HISTORIC PRESERVATION BOARD

Case No. H20-09
23 Public Sq./109 W. Washington

Historic Preservation Board September 10, 2020

Conditional sign approval – Candyapple & Co.

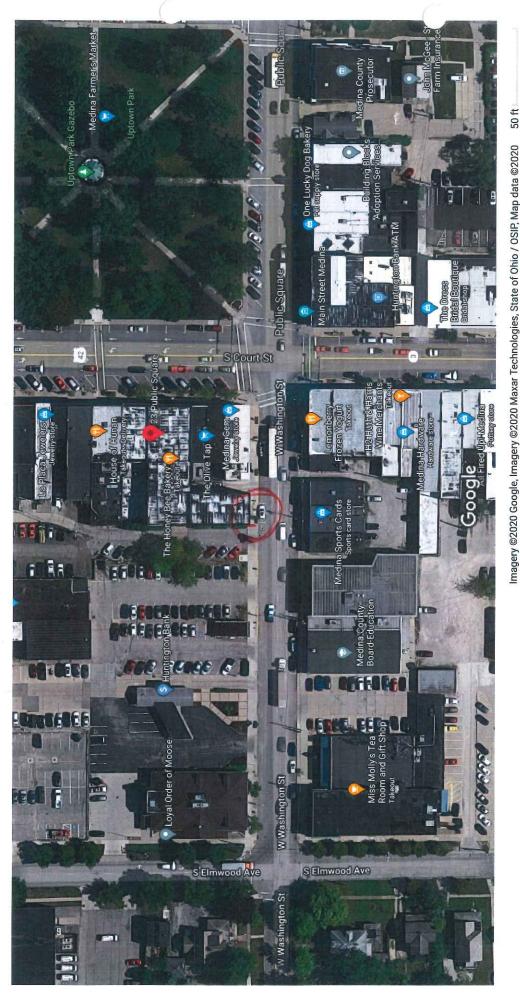
- Wall sign area is calculated at one sqft of sign area for every one linear foot of store frontage. The proposed wall signs comply with the sign code size requirements.
- The proposed projecting sign is 3.8 sq. ft. and compliant.

Sign Location: Section 1147.15(e) states that projecting signs shall be located not more than 14 feet above finished grade as measured from top of sign, and shall maintain a minimum vertical clearance of 8 feet from bottom of sign to finished grade. The proposed projecting sign complies.

The proposed signage is compatible with the district, the building and compliant with the conditional sign guidelines.

Staff recommends the Historic Preservation Board grant a conditional sign approval for the proposed Candyapple & Co signs at 109 W. Washington St.
